Request for Class II Permissive Change(C2PC)

FCC ID: VG8EM025FXX-Y

Please be notified that we, the undersigned, **Guangdong Midea Kitchen Appliances Manufacturing Co.,Ltd.** declare that the reasons for this class II permissive change are as below:

The new top /Bottom view

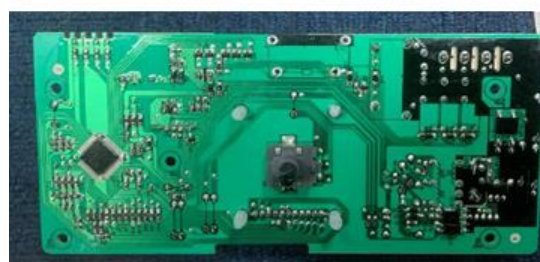
1. Changed Mother -board as below.
The original top /Bottom view

They have the same input, output and power except for PCB layout and some electronic component differences.
